Access Compliance Report

Public Rights-of-Way

(Curb Ramps)

Intersection ID: 13540	Main Street: LEXINGTON_AV	Cross Street: S_CALDWELL_ST	Location: N
ADA ID: 06B339CAB31B	Ramp Type: PerpDiag	Initial Pass/Fail: Fail	Overall Compliance: No
		Severity Score: 50

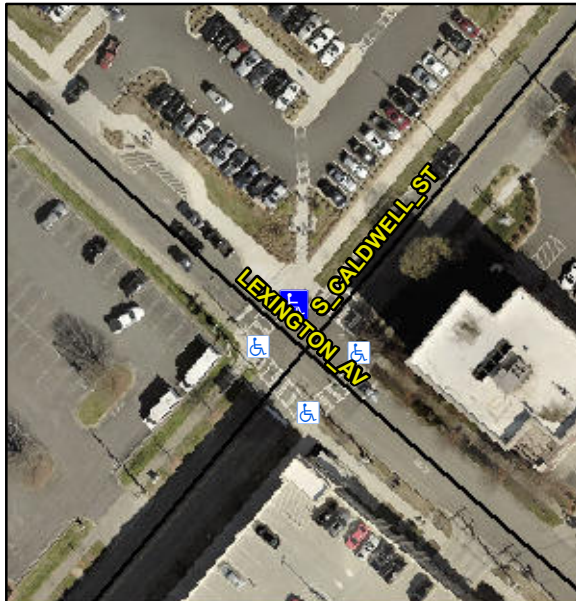
Not Found, R304.2.2, R304.5.3

Compliance	Description	Data	Compliance	Description	Data
N/A	Ramp Length (in)	68.0	No	Ramp Slope (%)	13.9
Yes	Ramp Width (in)	96.0	No	Ramp XSlope (%)	8.7
N/A	Flare Type LT	N/A	N/A	Flare Type RT	N/A
N/A	Flare Slope LT (%)	N/A	N/A	Flare Slope RT (%)	N/A
N/A	Flare Traversable LT?	N/A	N/A	Flare Traversable RT?	N/A
N/A	Landing Length (in)	N/A	N/A	DWS Provided?	N/A
N/A	Landing Width (in)	N/A	N/A	DWS Contrast?	N/A
N/A	Landing Slope (%)	N/A	N/A	DWS Length (in)	N/A
N/A	Landing X Slope (%)	N/A	N/A	DWS Full Width?	N/A
N/A	Landing Curb? (Y/N)	N/A	N/A	DWS Offset (in)	N/A
N/A	Shared Landing?	N/A			
N/A	Gutter Ponding?	Yes	N/A	Gutter Slope (%)	N/A
N/A	Gutter Lip Ht (in)	2.0	N/A	Gutter X Slope (%)	N/A
N/A	Painted X Walk1?	Yes	N/A	Painted X Walk2?	Yes
	X Walk 1 Direction	To SW		X Walk 2 Direction	To SE
N/A	X Walk 1 Width (in)	112.0	N/A	X Walk 2 Width (in)	112.0
	X Walk 1 Slope (%)	4.9		X Walk 2 Slope (%)	0.2
	X Walk 1 X Slope (%)	2.2		X Walk 2 X Slope (%)	3.7

Remove & Replace Curb Ramp With Two New Directional Ramps or Equivalent.
